PROJECT SILVER SPUR LPH

SUBJECT Drainage Plan -  
Silver Spur 6th Addition

## SUBDIVISION REPORT

Re: S/D 81-1 - Preliminary plat of Silver Spur 6th Addition

WICHITA KANSAS  
 SIXTH ADDITION

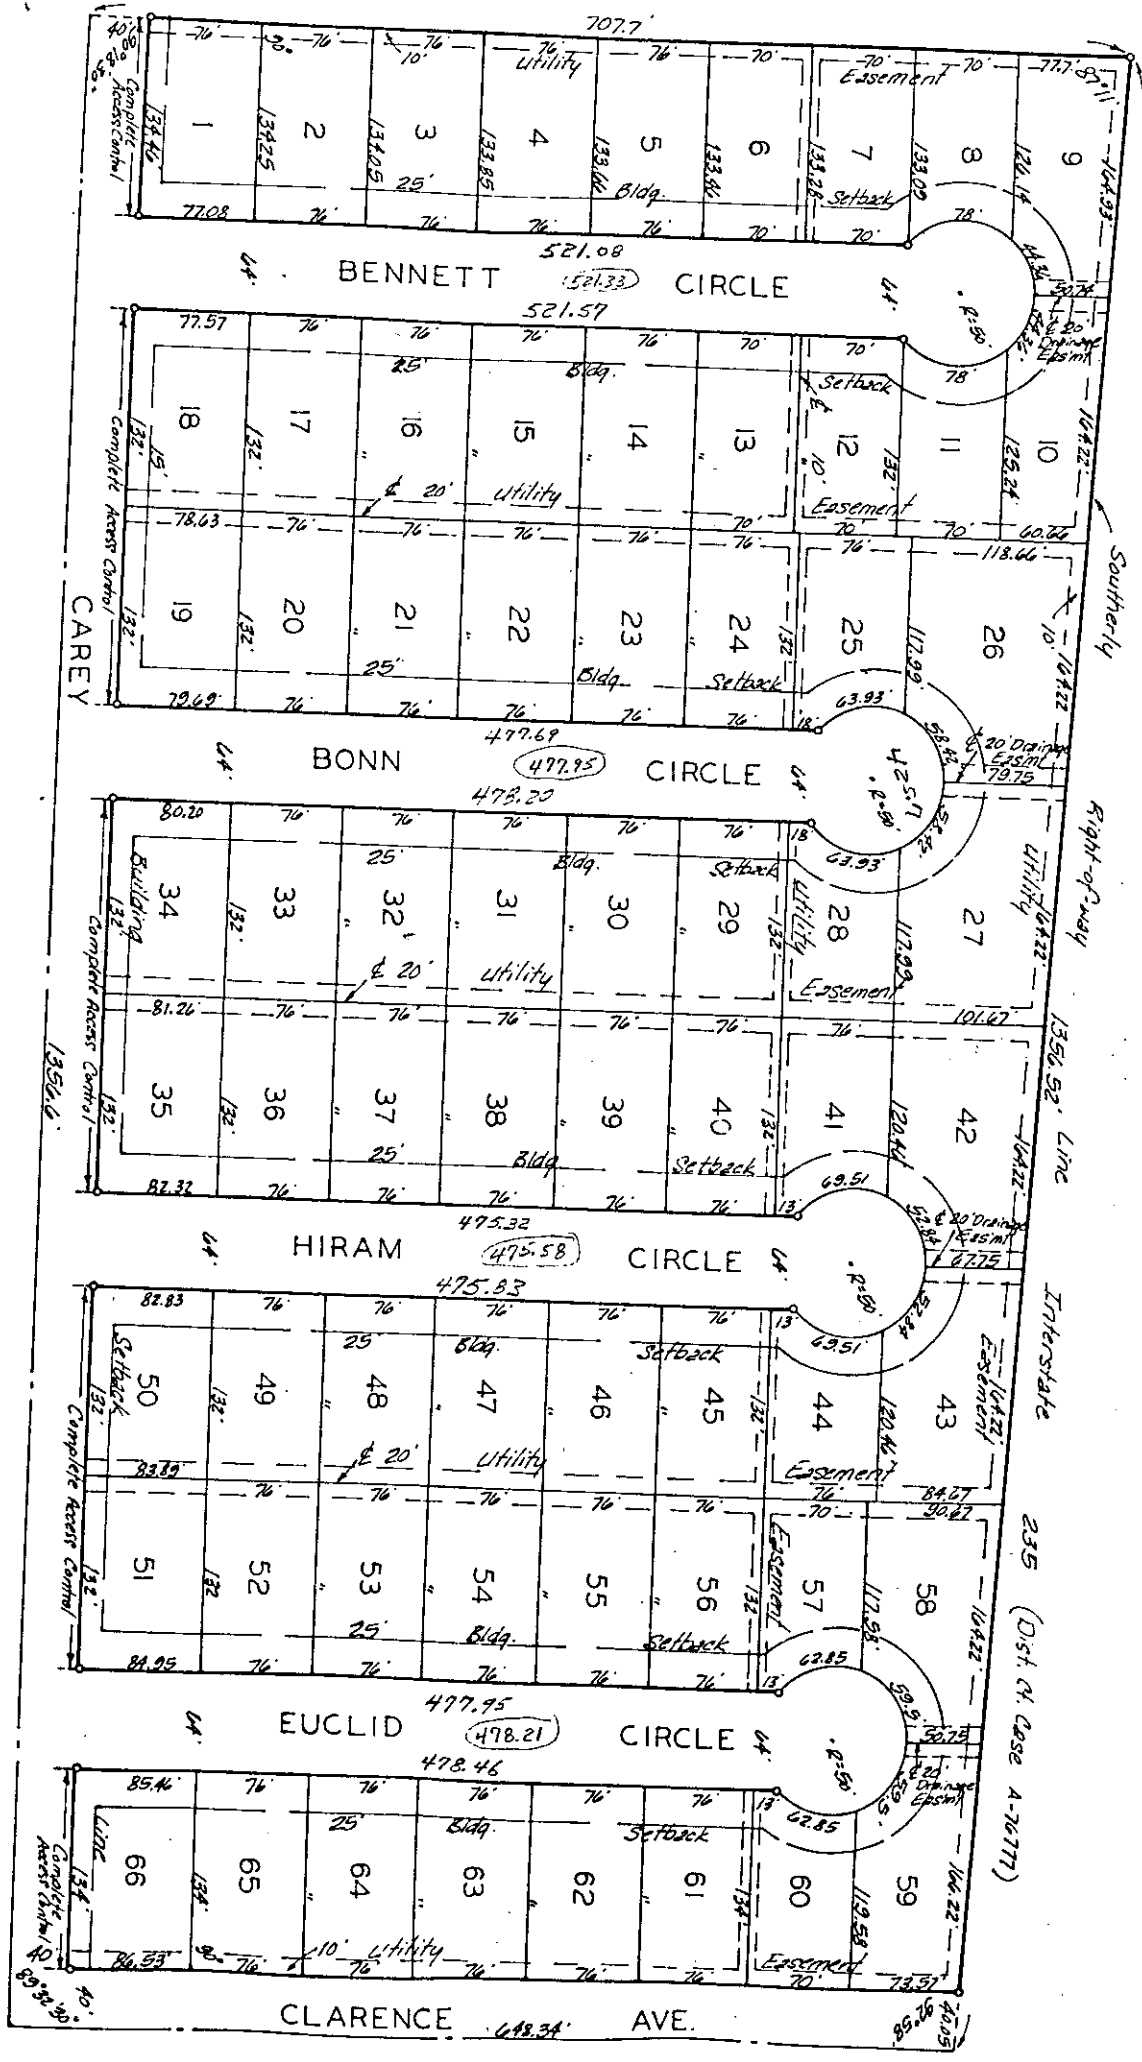
- A. The City Engineer's representative shall be prepared to comment on the final drainage plan and whether a minimum pad elevation is required on any of the lots. The applicant shall guarantee any drainage improvements required for implementation of the approved drainage plan.

- B. *Planning* The applicant shall guarantee the paving of the four cul-de-sac streets as well as Carey adjacent to this plat. The applicant shall attempt to obtain a valid petition for paving Carey from Seneca to Meridian. The paving width for Carey can be 25 feet if no direct access to Carey from individual lots is needed.

- C. Since Carey is a designated collector street, the guarantee shall include a sidewalk on both sides.
- D. The applicant shall guarantee the extension of sanitary sewer to serve each lot being platted.

CLEVELAND FOR SIXTH ADDITION  
WICHITA KANSAS

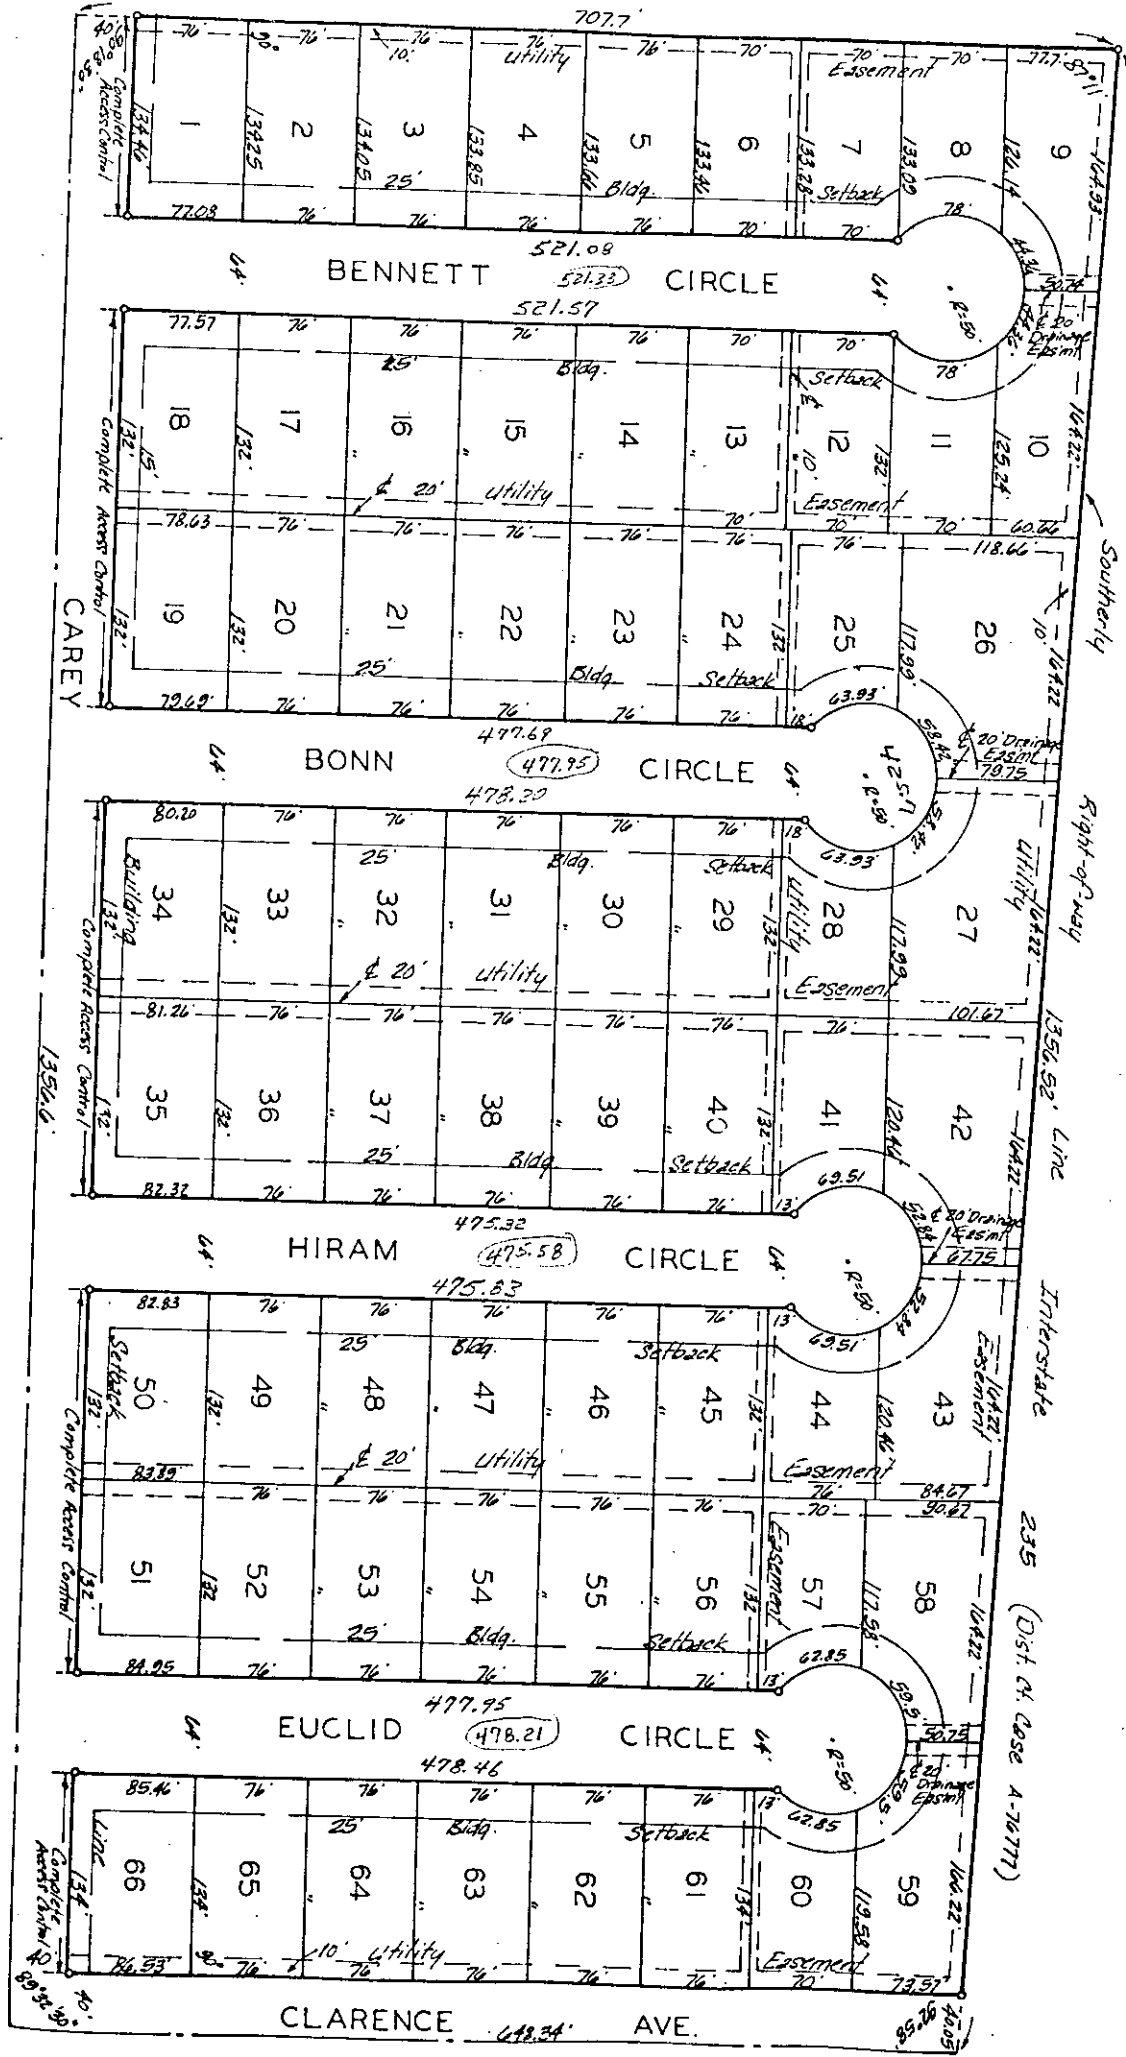
- A. The 26-foot strip of ground east of Lots 59 thru 66 is part of Lot 1, Silver Spur Addition and should be included in this plat as part of lots or, if necessary, as part of Clarence Avenue for street or drainage purposes.

- B. The final plat shall indicate a minimum pad or lowest floor elevation of 95.0 City Datum for lots in the east portion of this plat. The Engineering Department should be contacted about this prior to preparing the final plat.

- C. The applicant shall guarantee any drainage improvements required by the platting of this property.
- D. The proposed cul-de-sacs shall be labeled "Circles" rather than "Courts."

- I. If improvements are guaranteed by petition, a notarized certificate listing the petitions shall be submitted to the Planning Department for recording.
- J. Side lot utility easements as requested by K. G. and E. and marked on the enclosed copy of the preliminary plat shall be shown on the final plat.
- K. The applicant shall install or guarantee the installation of all utilities and facilities which are applicable and described in Article 8 of the MAPC Subdivision Regulations.
- L. Requirements for a final plat (see pages 20-25, Part 4, Article 5 of the MAPC Subdivision Regulations).

Enclosed herewith is the "marked" copy of the preliminary plat for your information and files.
